TAHMOOR COLLIERY – MODIFICATION OF MINE PLAN

Director-General's
Assessment Report

Section 96(2) of the
Environmental Planning and Assessment Act 1979

October 2006

Figure 2: Tahmoor Colliery – Current and Proposed Mine Workings and Development Consent Areas

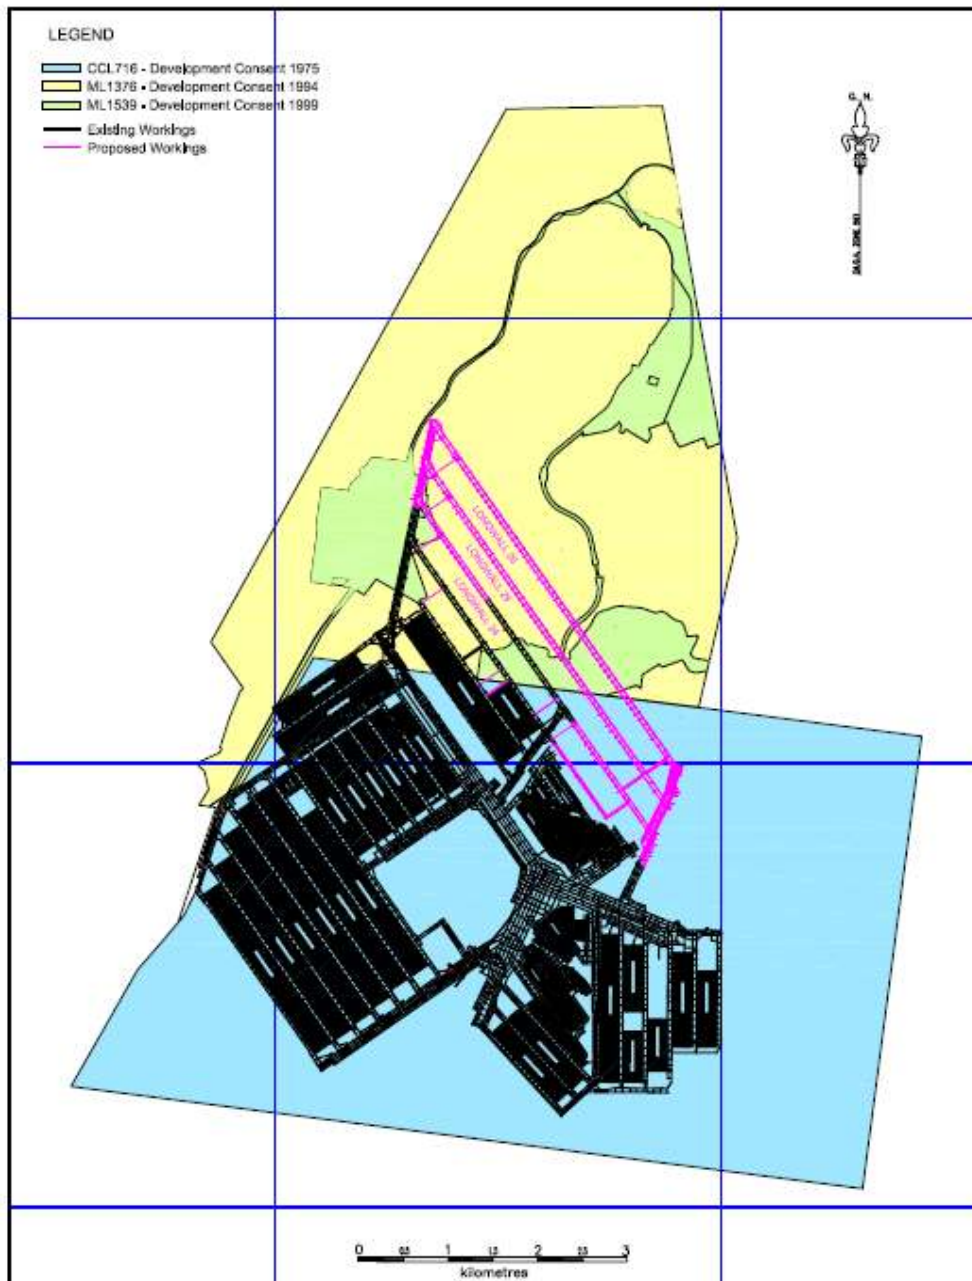
This is because Areas 4 and 5 are directly aligned with the Hospital (see Figure 2 of the consent). These two areas were originally excluded from the limits of subsidence in the 1998 EIS solely as an outcome of the commitment to not subside the Hospital's main building. Approval to extract coal and cause subsidence within Areas 4 and 5 therefore raises the question of whether subsidence is now intended by the Applicant beneath the Hospital.

Figure 3: Tahmoor Colliery – Areas where Subsidence is not Permitted under the 1999 Consent

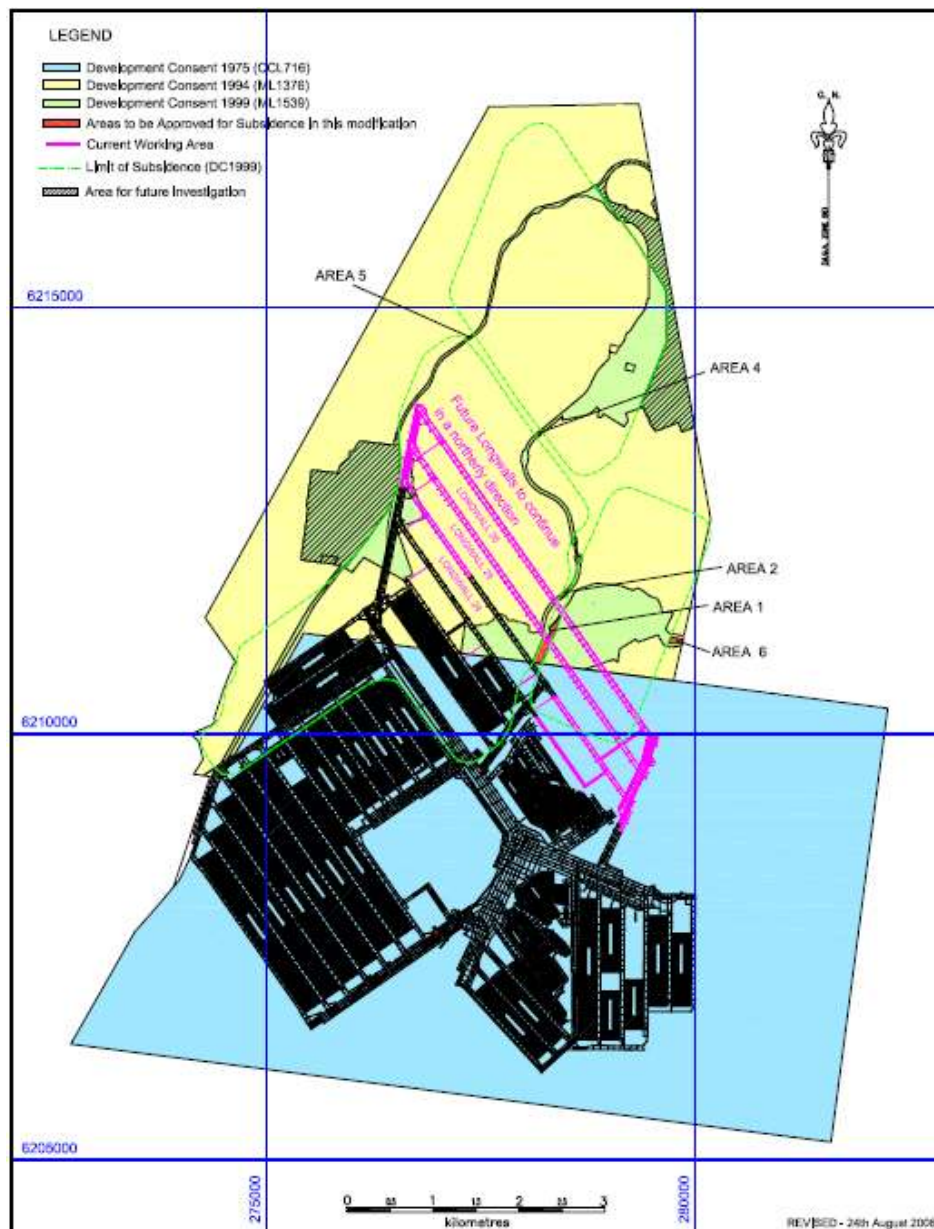
The Applicant is proposing changes to its longwall panel layout that would increase the limits of subsidence shown in Figure 2 and therefore require modification to the consent. The SEE reports that the revised panel layout is based on a better understanding of the geological setting, leading to a more efficient orientation of longwall blocks. In essence 3 domains of longwall panels of around 2.2 km in length proposed in the 1998 Environmental Impact Statement (EIS) are being replaced with a single, larger domain of panels of up to 4 km in length. The subsidence footprints associated with the 3 previous longwall domains, as shown in Figure 2 of the consent, are outlined in green in Figure 3, below. A number of panels representing the new mine plan are shown in pink.

The application now seeks approval to modify the limit of subsidence shown in Figure 2 of the consent so as to permit subsidence within 5 small areas (labelled Areas 1, 2, 4, 5 and 6 and shown in red in Figure 3, above). There are also two larger areas (black hatched and labelled "Area for future investigation") where subsidence is not currently permitted but which are not subject to the present application. Following the Applicant's withdrawal of Area 3 from further consideration at this time, it has also labelled this as an area for future investigation.

The area labelled "Area 3" within the SEE comprises a double-track railway tunnel in a small section of the Main Southern Railway corridor which is outside of the approved limit of subsidence within the consent. The area in question is shown in Figure 3 as a small area of black hatching north of Area 2 and between the approved limits of subsidence.

- amend condition 6 and replace Figure 2 in order to clarify the areas where the Applicant is not permitted to cause subsidence under the consent (ie the areas marked "Areas for future investigation" on Figure 3 above);
- amend condition 6(i) and Figure 3 in order to allow a calculation of subsidence damage impacts based on percentages of structures in existence from time to time (rather than in 1998);
- replace the requirement in the previous condition 27 for additional development consent from the Council with a requirement for the "approval" of Council;
- require the Applicant to place on its website particular information relating to environmental management of the mine, in order to improve community access to this information; and
- to otherwise update, clarify or make minor corrections to a number of conditions.

Figure 4: Tahmoor Colliery – Area 1 in Tahmoor, showing Built Structures

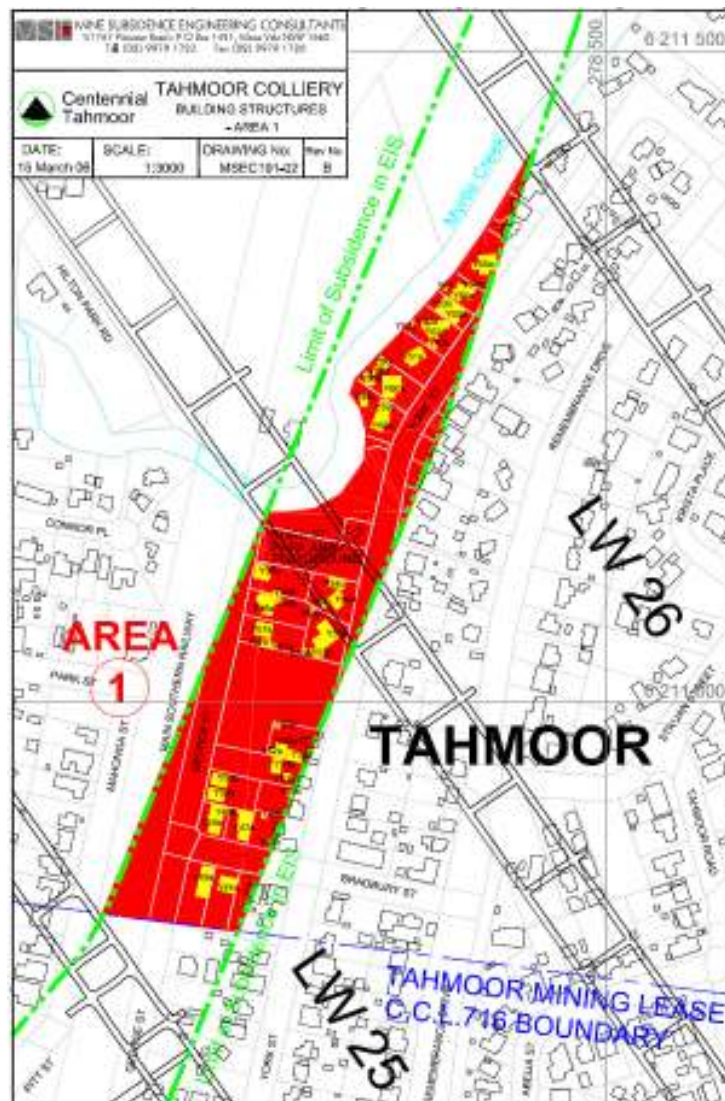
Area 1 is the largest of the 5 areas and is located within the urban area of Tahmoor. It comprises 4.6 hectares and contained 17 houses, 1 small block of units, 27 sheds and 3 private swimming pools at the time of the assessment (see Figure 4).

The anticipated subsidence impacts reported in the 1998 EIS for residences and other buildings and structures in Tahmoor were based on the statistical distribution of measured strains over the Colliery's Longwalls 3 to 7 and 9 compared with that for the length of the structures. The same method of assessment of strain impacts has now been applied by MSEC to the 17 houses and the block of units in Area 1. MSEC assessed that 15 of these residences would experience Category 0 (Negligible) Strain Impacts, 2 would experience Category 1 (Very Slight) Strain Impacts, and 1 would experience Category 2 (Slight) Strain Impacts.

- 41 of the total 48 structures in Area 1 are predicted to experience Category A (Negligible) Tilt Impacts and 7 structures (including 3 houses) are predicted to experience Category B (Tolerable) Tilt Impacts; and
- 28 of the structures are predicted to experience Category 0 Strain Impacts and 19 structures (including 15 houses) are predicted to experience Category 1 Strain Impacts.

Both methods of assessment concluded that the proposed changes to the mine layout would not lead to any increase in the number of impacts in either the moderate, severe or very severe damage assessment categories.

In essence, the subsidence impact assessment found that the buildings and other structures in Area 1 would behave similarly to those in the rest of Tahmoor if subjected to the anticipated mine subsidence. There is nothing unique about these buildings or the changed orientation of longwall mining which would cause them to behave differently.
